ZHL-1724MLN+ PCN Report

AN-60-095

ORIGINAL PART: ZHL-1724MLN
 REPLACEMENT PART: ZHL-1724MLN+

CASE STYLE

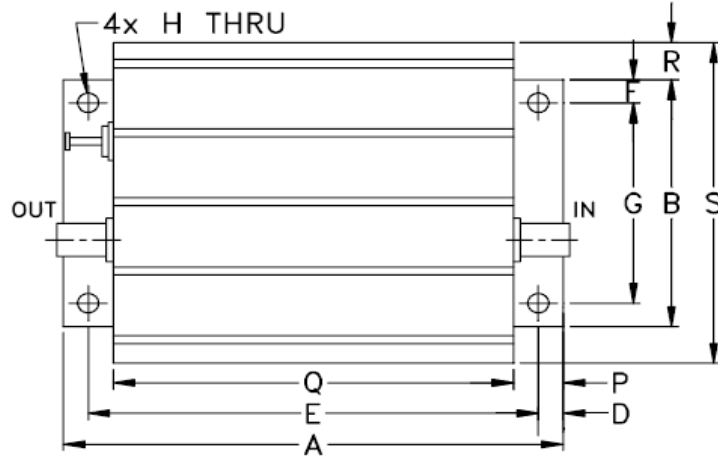
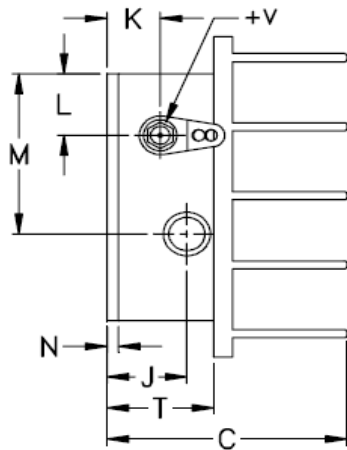
CASE STYLE: S32, No change

COMPARISON PERFORMANCE CURVES^a: T_{AMB}=25°C

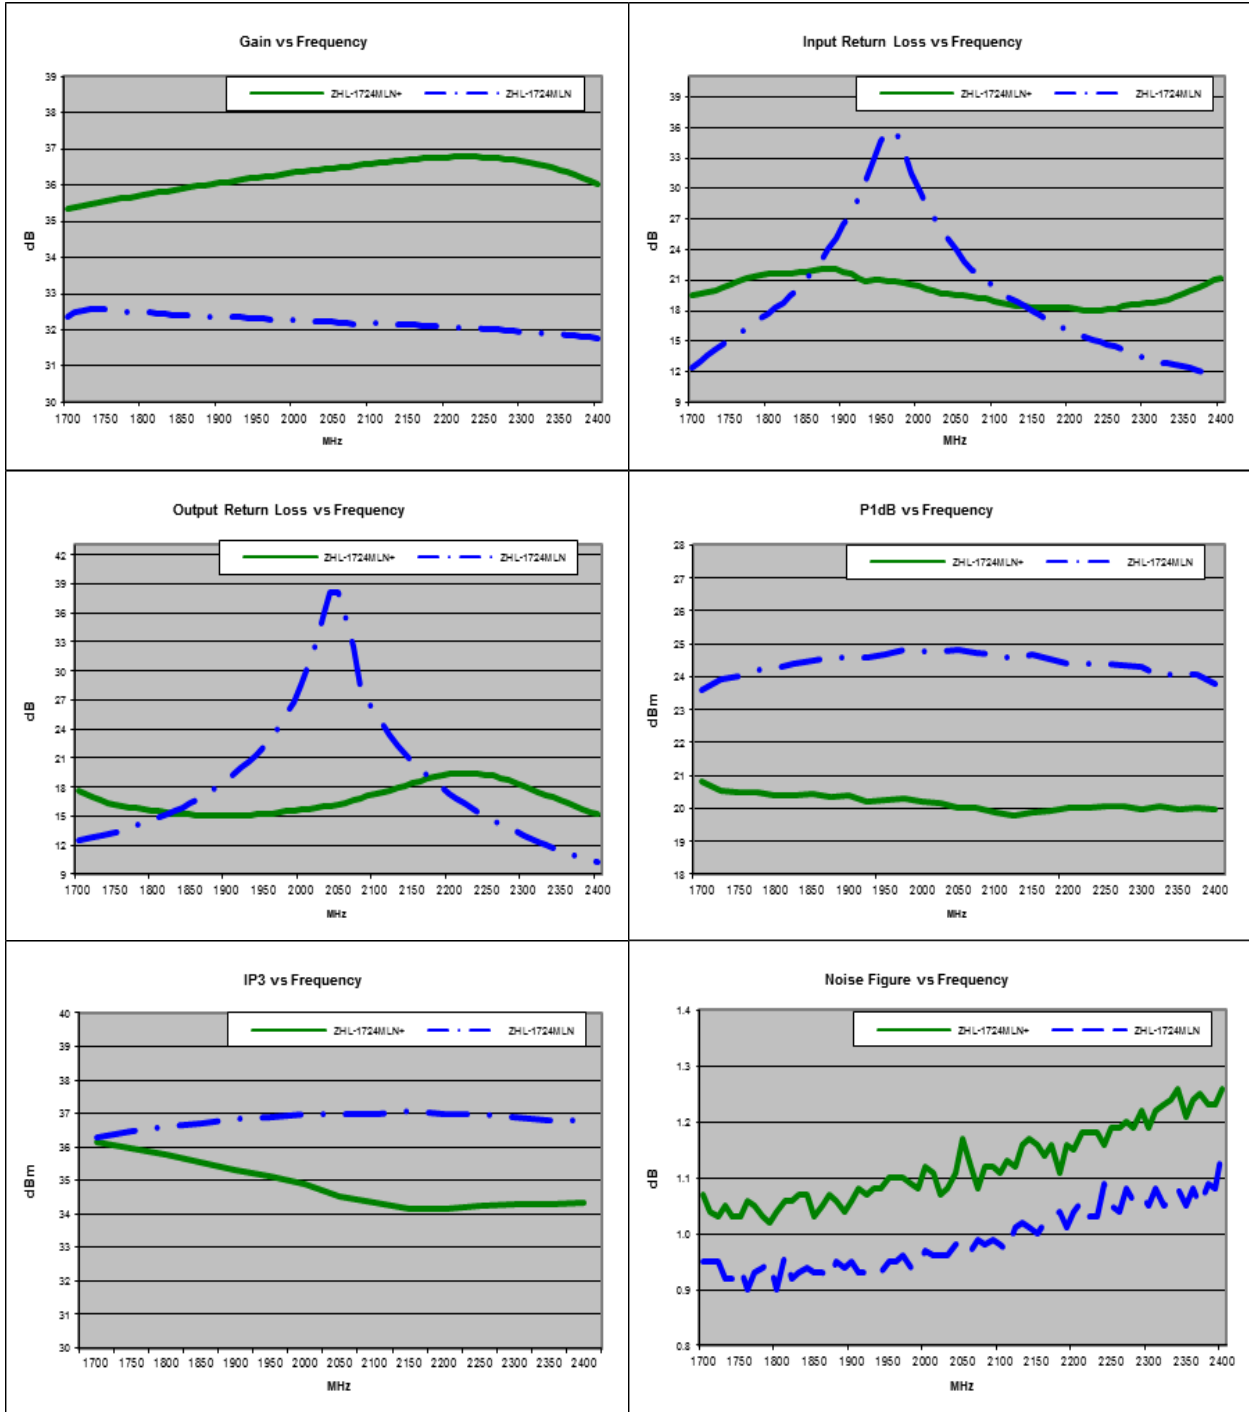
Parameter	Freq (MHz)	ZHL-1724MLN ORIGINAL PART		ZHL-1724MLN+ REPLACEMENT PART	
		Min	Max	Min	Max
Gain (dB)	1700-2400	31.76	32.57	35.37	36.78
Gain Flatness (dB)	1700-2400	-----	+/-0.40	-----	+/-0.71
Input VSWR (:1)	1700-2400	-----	1.72	-----	1.33
Output VSWR (:1)	1700-2400	-----	1.89	-----	1.60
Pout 1dB (dBm)	1700-2400	23.59	24.80	19.78	20.89
Pout 3dB (dBm)	1700-2400	24.65	25.76	21.26	22.00
OIP3 (dBm)	1700-2400	36.27	37.07	34.17	36.17
Noise Figure (dB)	1700-2400	.90	.99	1.02	1.32
DC Voltage (V)	-----	-----	17	-----	17
Supply Current (A)	-----	-----	0.238	-----	.356
